HPA State Diagram and Descriptions

To: T13 Technical Committee
From: Joseph Chen
Samsung
75 W. Plumeria Drive
San Jose, CA 95134
Phone: 408-544-5766
Email: joseph.chen@samsung.com
Date: Feb 20, 2007

This document contains three major sections: HPA feature set description changes, new HPA state diagram, and HPA state transition descriptions.

1. HPA Not Set State Diagram

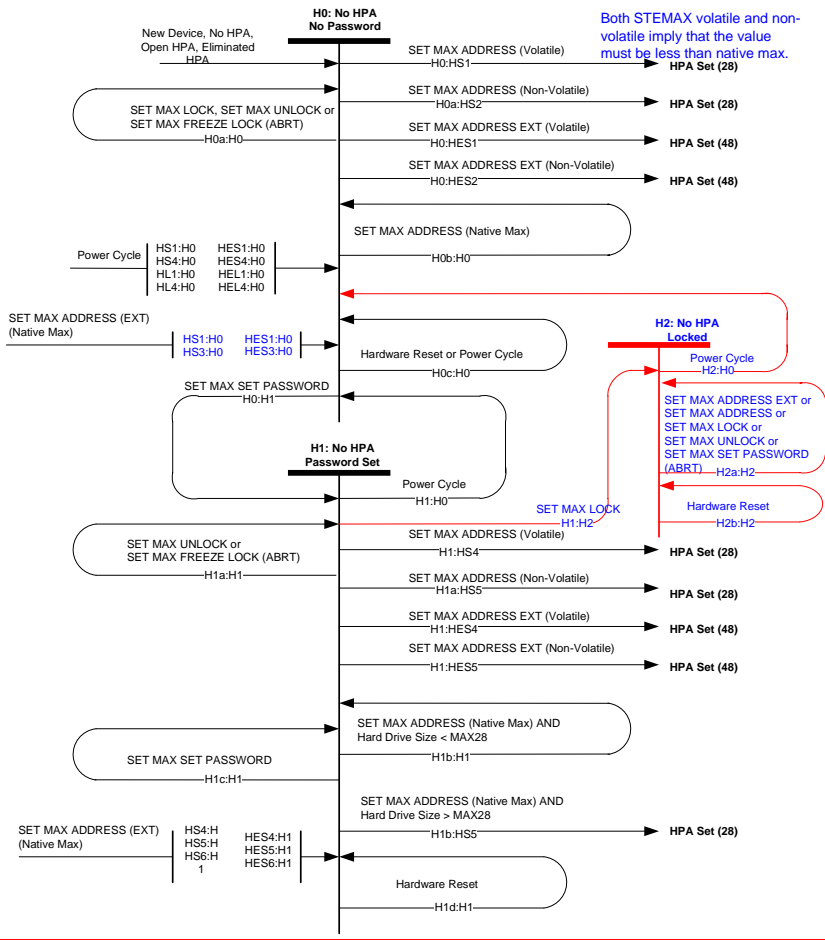
Deleted: <#>HPA is said to be *Open* or *Eliminated* when a SET MAX ADDRESS (EXT) is done at READ NATIVE MAX (EXT) return parameter. ¶
 <#>To redefine maximum address SET MAX ADDRESS (EXT) command shall be immediately preceded by a READ NATIVE MAX (EXT) command. If these commands are not immediately preceded by a READ NATIVE MAX (EXT) command, they will be aborted (ABRT). ¶
 <#>To provide optional security extensions SET MAX SET PASSWORD, SET MAX LOCK, SET MAX UNLOCK, SET MAX FREEZE LOCK commands shall not be immediately preceded by a READ NATIVE MAX (EXT) command. If these commands are immediately preceded by a READ NATIVE MAX (EXT) command, they shall be interpreted as a SET MAX ADDRESS (EXT) command. ¶
 <#>Only one SET MAX ADDRESS non-volatile allowed per power cycle ¶
 <#>Volatile state means no non-volatile SET MAX ADDRESS (EXT) command has been issued after a volatile one. ¶
 <#>Non-Volatile 1 state means a non-volatile SET MAX ADDRESS (EXT) command was issued after power cycle. ¶

<#>Non-Volatile 2 state means no non-volatile SET MAX ADDRESS (EXT) command was issued after power cycle ¶
 <#>Maximum number of failed password attempts is defined by MAX_BAD (5 attempts) ¶
